**UNITED STATES ENVIRONMENTAL PROTECTION AGENCY
REGION 8**

Re: US Magnesium Superfund Site, Rowley, Utah
Final Phase 1A Sampling and Analysis Plan

EPA Response to ERM and US Magnesium May 21, 2013, Letter

Figure 1: Risk Assessment Process Diagram (September 16, 2013)

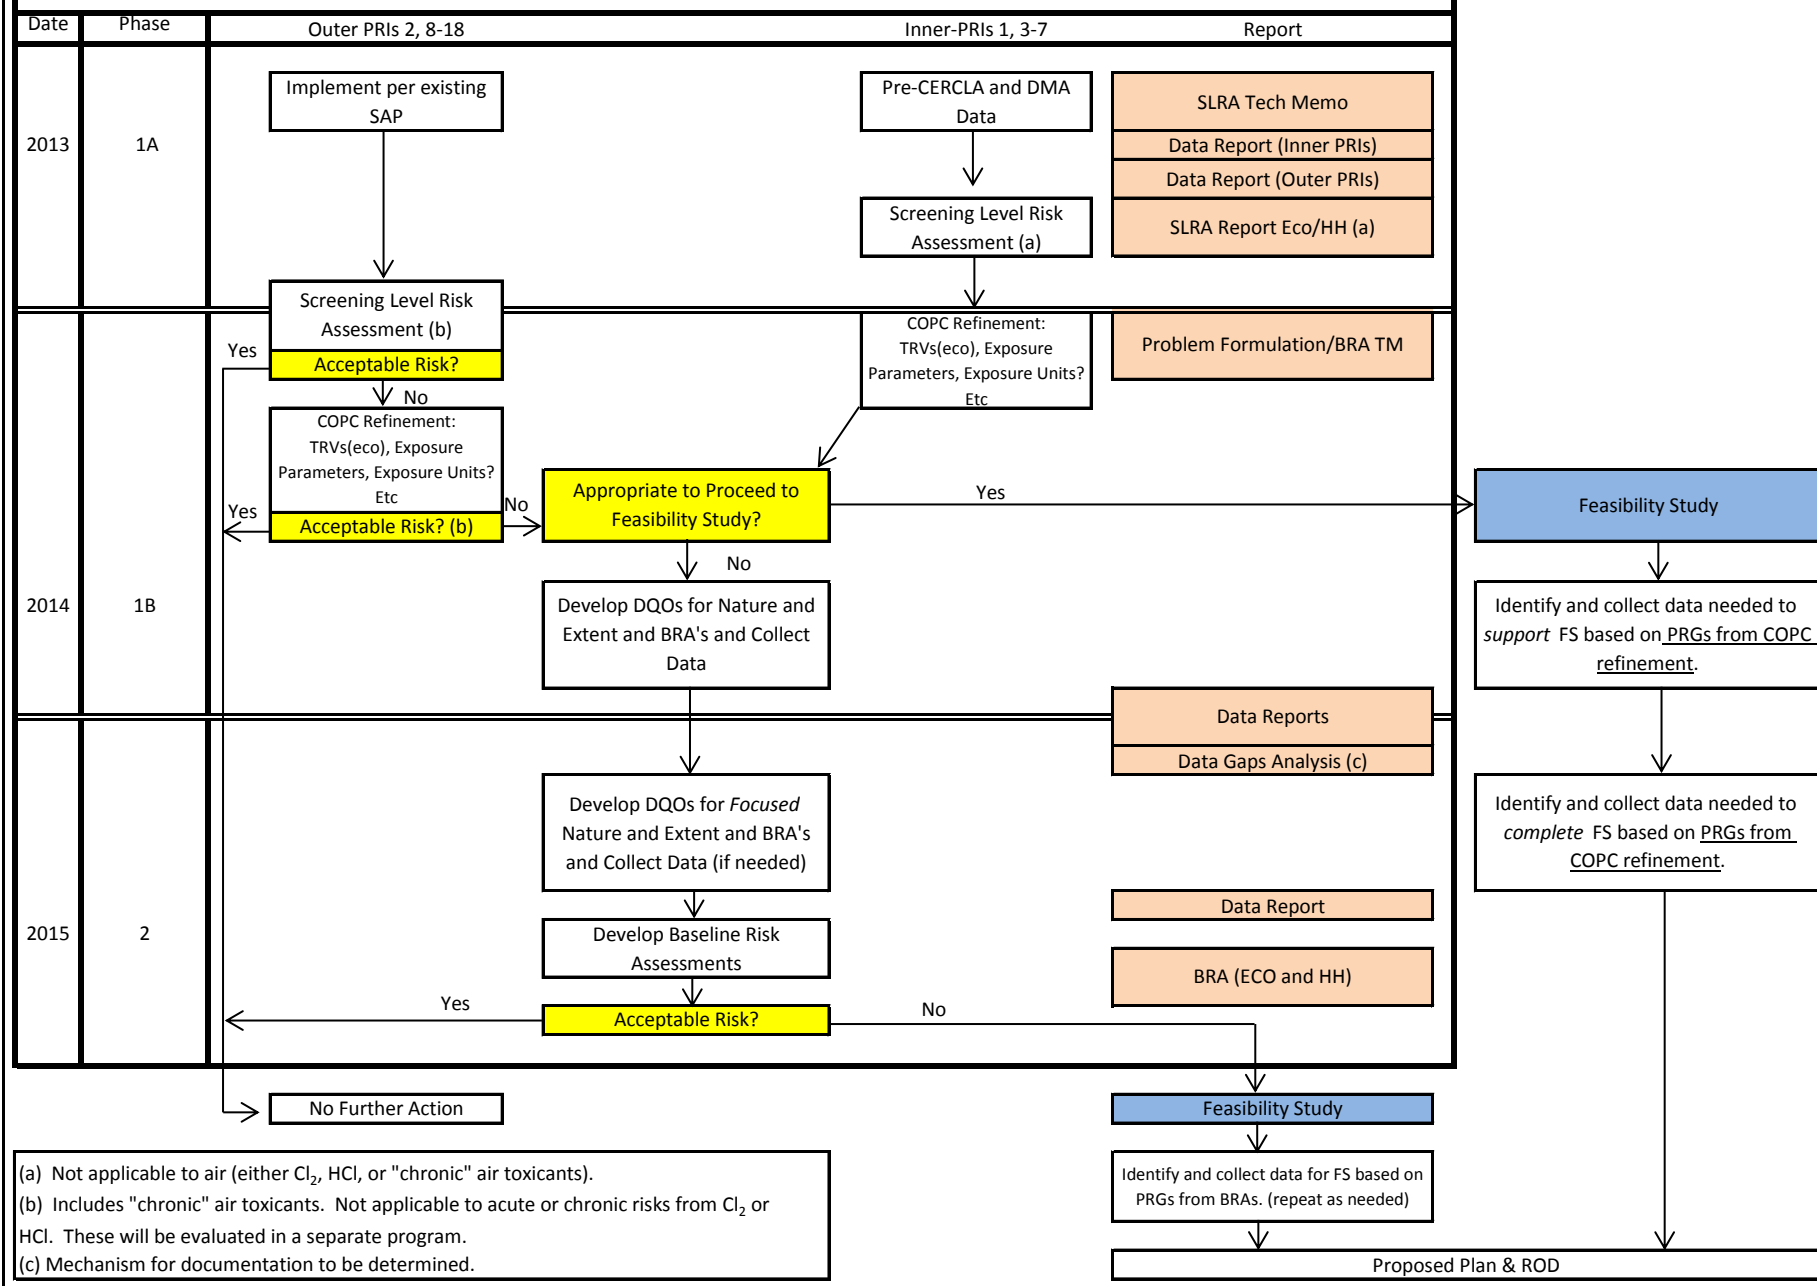
The EPA's proposed site characterization and risk assessment approaches for both the outer and the inner PRIs are outlined in the attached Figure 1: Risk Assessment Process Diagram. The approach shown for the outer PRIs is the approach currently contained in the Phase 1A SAP. The approach for the inner PRIs requires that ERM and USMag complete a SLRA of solid media and water using existing site data and adopt, for purposes of the FS, the PRGs identified after the refinement of COPCs. Due to the limitations of the existing site data and associated uncertainties, the approach for the inner PRIs outlined in the diagram does not allow for the elimination any COPCs through the SLRA step. The PRGs identified would be considered by the EPA and the State of Utah in establishing the remedial action objectives (pursuant to SOW Sec 5.5) that will form the foundation for:
